**Development Application  
59 Cudgegong Road Rouse Hill Site 1  
DA SPP-17- 400007**

**2017SWC068 - Blacktown – DA17-00007**

**Address – 59 Cudgegong Rd, Rouse Hill, Proposed Lot 1 in subdivision of Lot 74 DP208203**

*Description – Construction of 2 x 8 storey residential flat buildings comprising 163 apartments, 229 car parking spaces in 2 basement levels and associated civil and landscaping works.*

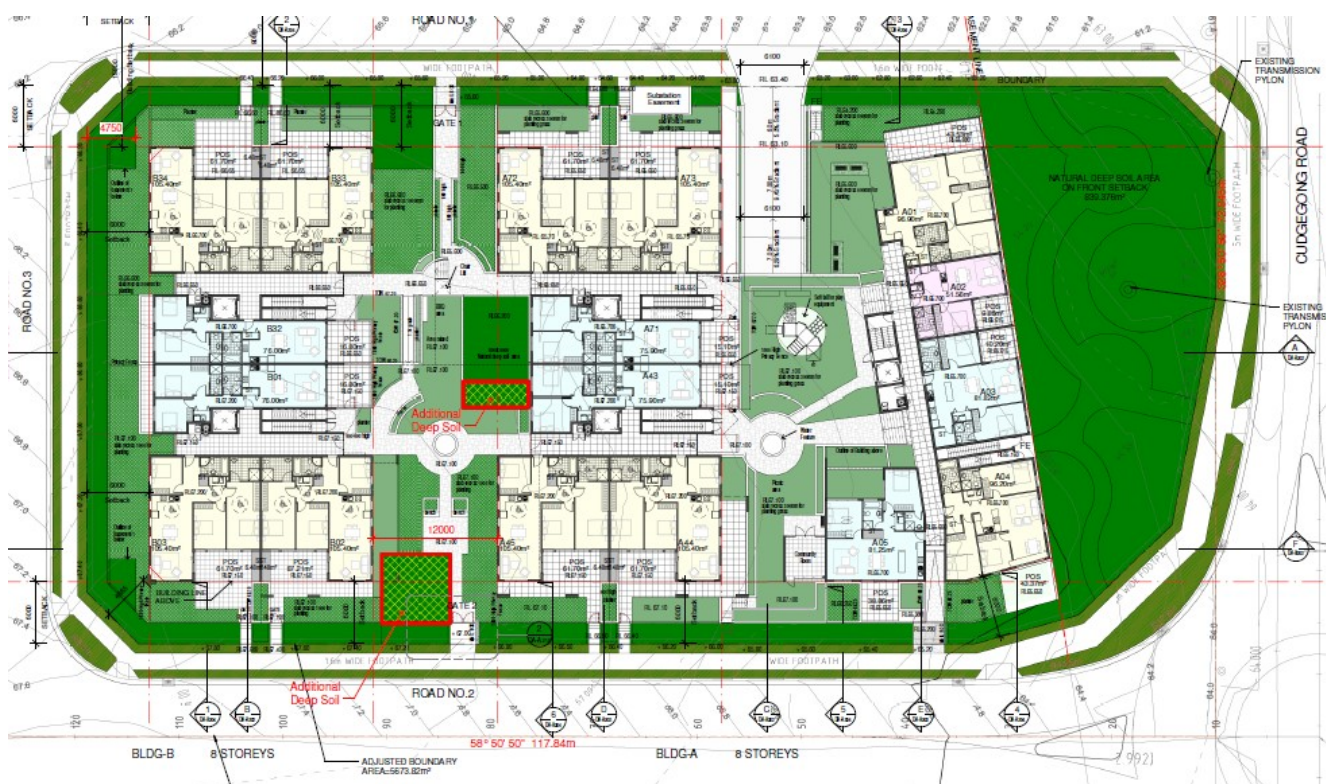
*However, they are concern that the proposal now provides 46 car spaces in excess of the Council's requirements and yet remains deficient in deep soil landscaped area. They thought that there must be scope to reduce the size of the basement and thereby increase the extent of deep soil landscaping, particularly between the buildings. They accept that the revised application provides an improved outcome and goes a long way towards addressing the deficiencies identified at the meeting of 24 April 2019. However, they would like the staff to investigate and discuss options with the applicant to improve deep soil landscape area by reducing the number of car parking spaces given the site's access to new transport infrastructure.*

Essentially the Panel has requested that consideration be given to an increase in deep soil and a corresponding reduction in on site car parking. It is noted that the request has been made notwithstanding that the proposal considered by the Panel was fully compliant with both the deep soil controls and the on-site car parking rates applying to the development under SEPP No 65 and the ADG (refer to comments in sections 1 and 2 of this correspondence). On this basis it is respectfully suggested that approval of the development application as proposed would have been a reasonable outcome.

The accompanying amended plans achieve this outcome. Essentially there has been a further reduction of eight (8) on site car parking spaces with a corresponding increase of 59sqm in deep soil landscaping.

The additional deep soil zones have been located at the main pedestrian entry from the southern street frontage (between blocks A and B) and within the central common open space (between blocks A and B) as shown in the following plan extract.

The additional deep soil has been strategically placed to improve the amenity of the common open space area and enhance the pedestrian entry/street presentation of the development.

Under the proposed amendments the total deep soil area (including only areas with a dimension of 6m or more in any direction) increases from 889.54sqm or 10.48% of the site area to 948.5sqm or 11.17% of the site area. The total site deep soil (including areas less than 6m but excluding planting on structures) increases from 1,292.96sqm or 15.23% of the site area to 1,352sqm or 15.92% of the site area.
